**CERTIFICATE OF APPROPRIATENESS**

**Property:** 802 W. Temple Street, Lot 9, Block 218, East Norhill Subdivision. The property includes a historic 2,004 square foot, one-story brick veneer single-family residence and a detached garage situated on a 6,157 square foot (59' x 104') corner lot.

**Proposal:** Alteration – Replace 19 original wood 1-over-1 sash windows with 19 1-over-1 wood replacement windows.

**Recommendation: Partial Approval:**

**PHOTOS SUBMITTED BY APPLICANT**

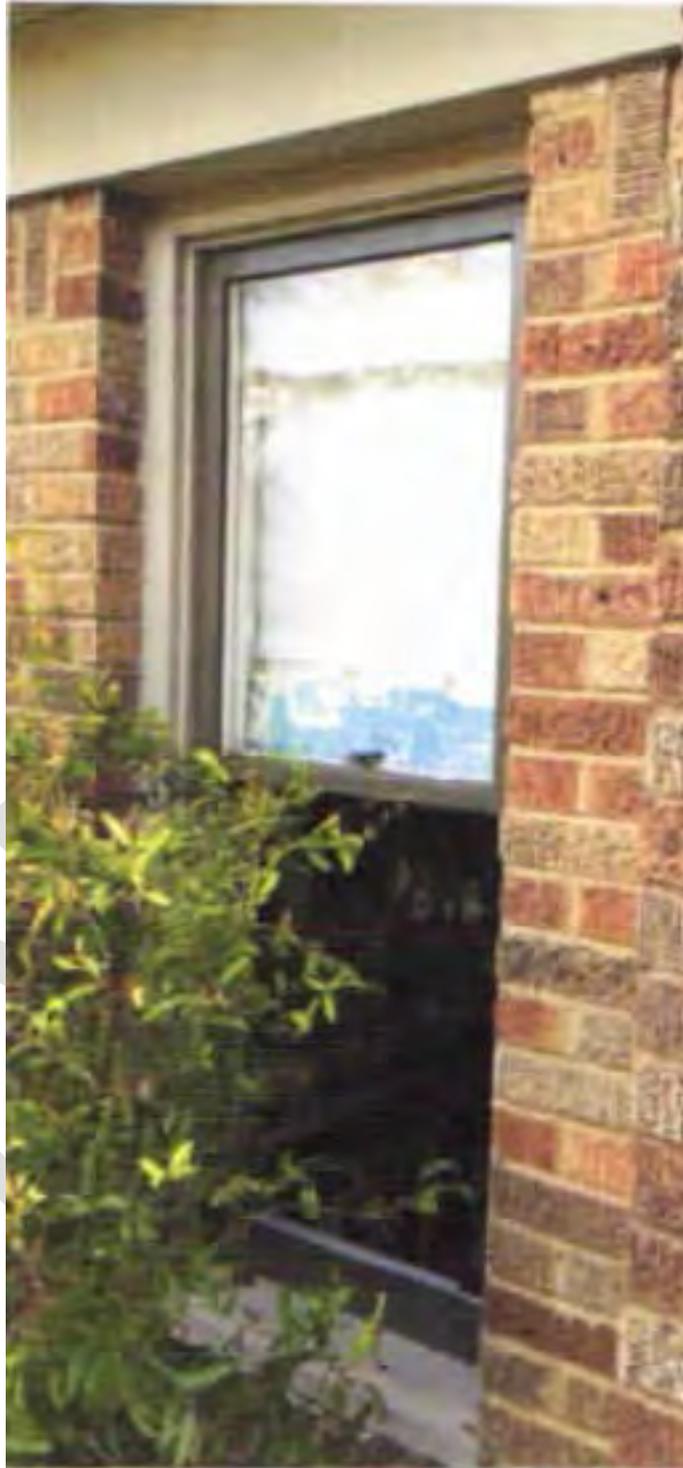
**Approval to replace the bottom sash of window I.**

**Denial to replace windows A, B, C, D, E, F, G, H, J, and K**

STAFF PHOTOS

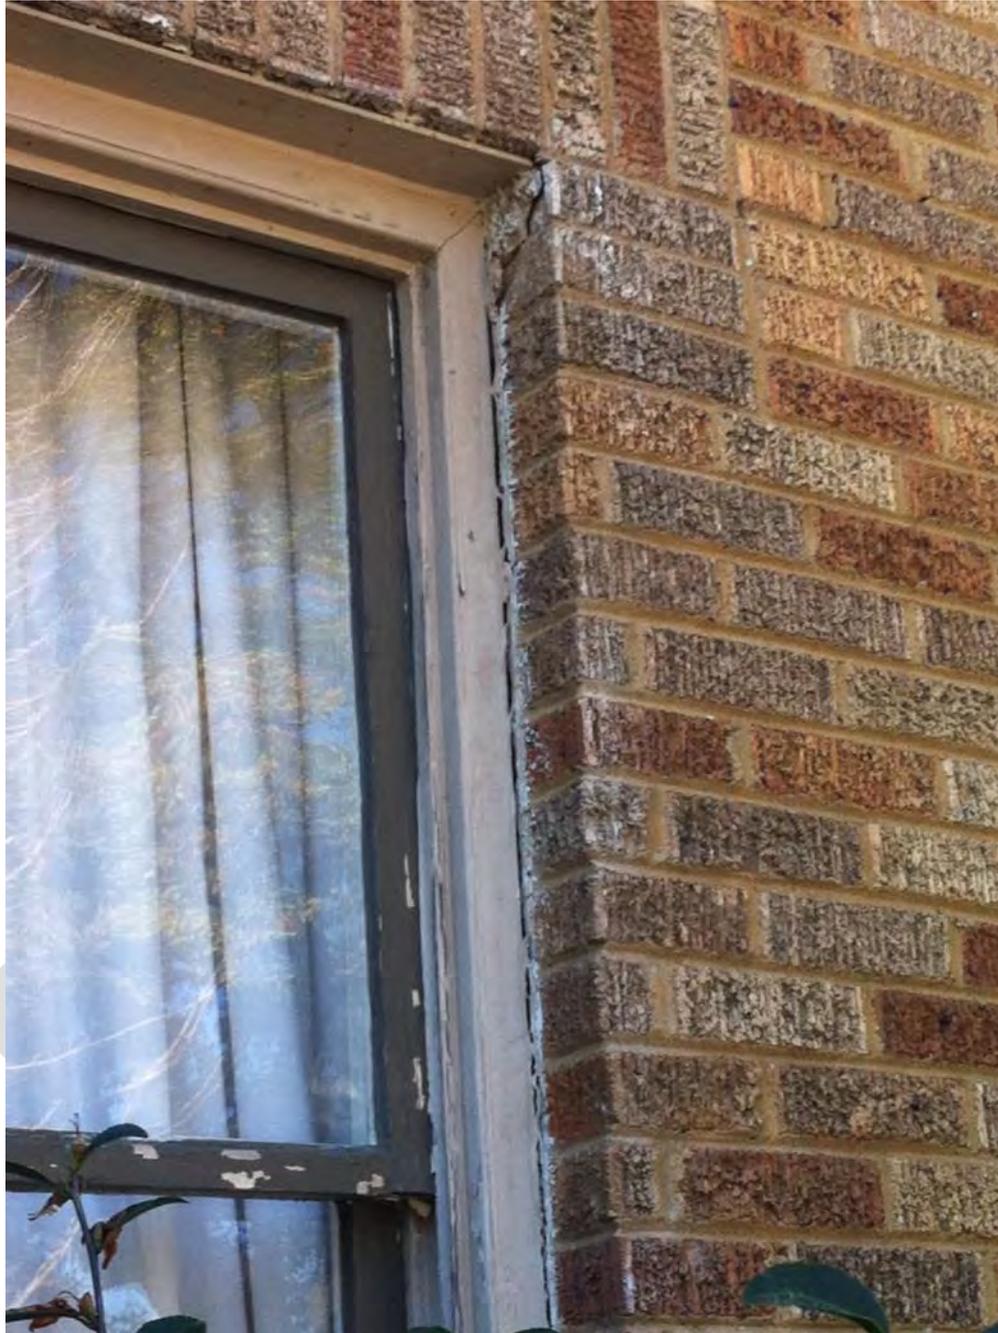
Staff and the Senior Structural Inspector visited the site to verify the condition of the windows. Some of the windows show signs of deferred maintenance and one window is past the point of repair. It was determined that the majority of the windows are in good condition and can be repaired. The exterior sills are deteriorated and damaged to where they cannot be repaired and warrant replacement. The deteriorated sills are causing water ingress resulting in subfloor damage and damage to the interior flooring.
